Preliminary Report on Metrolink Route and its Potential Effect on AerCap House

Waterman Moylan Consulting Engineers Limited

Client Name: Hines
Document Reference: 22-117r.101
Project Number: 22-117

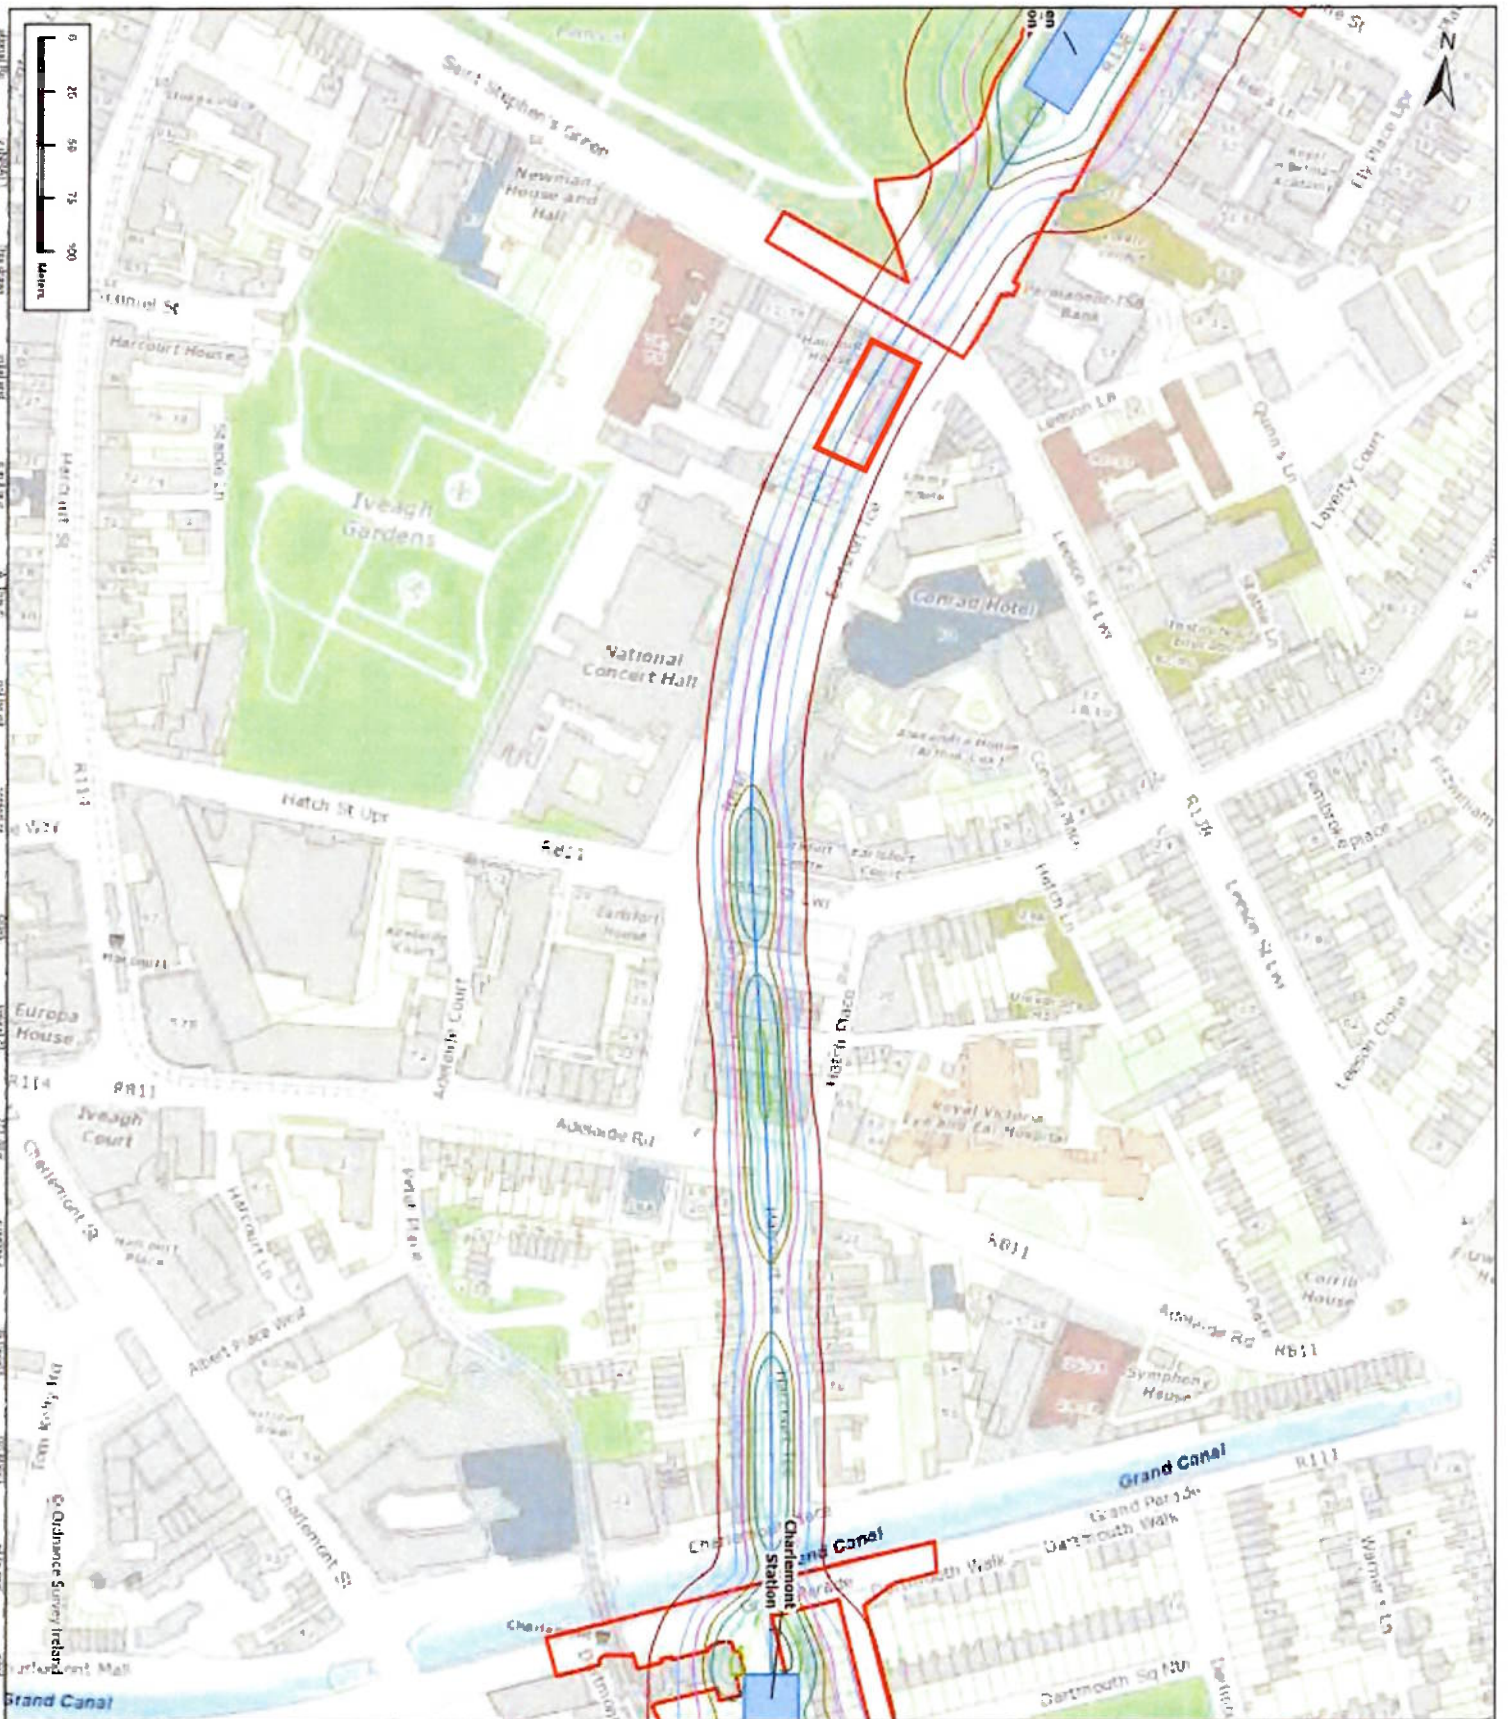
We have added the relevant information Exclusion Zones, and Limits of Deviation to Jacobs/IDOMs drawing number ML1-JAI-ARD-ROUT_XX-DR-Y-01018 included in Appendix B of this Report. We have also indicated the location and volume of the substructure and superstructure of AerCap House.

Based on the overlay, it is clear that the substructure to the basement is located at the top of the exclusion zone as presented DOC ML1-JAI-GEO-ROUT_XX-RP-Y-00034.

A detailed Phase 3 assessment using the correct building geometry and structural form should be completed and independently verified, ensuring the maximum damage caused to AerCap House is limited to 0.1mm cracking. The proposed tunnel elevation may require to be lowered more than the current LOD downwards, i.e. more than the 10.0m indicated in the Wider Effects Report submitted as part of the application, considering the proximity and sensitivity of AerCap House.
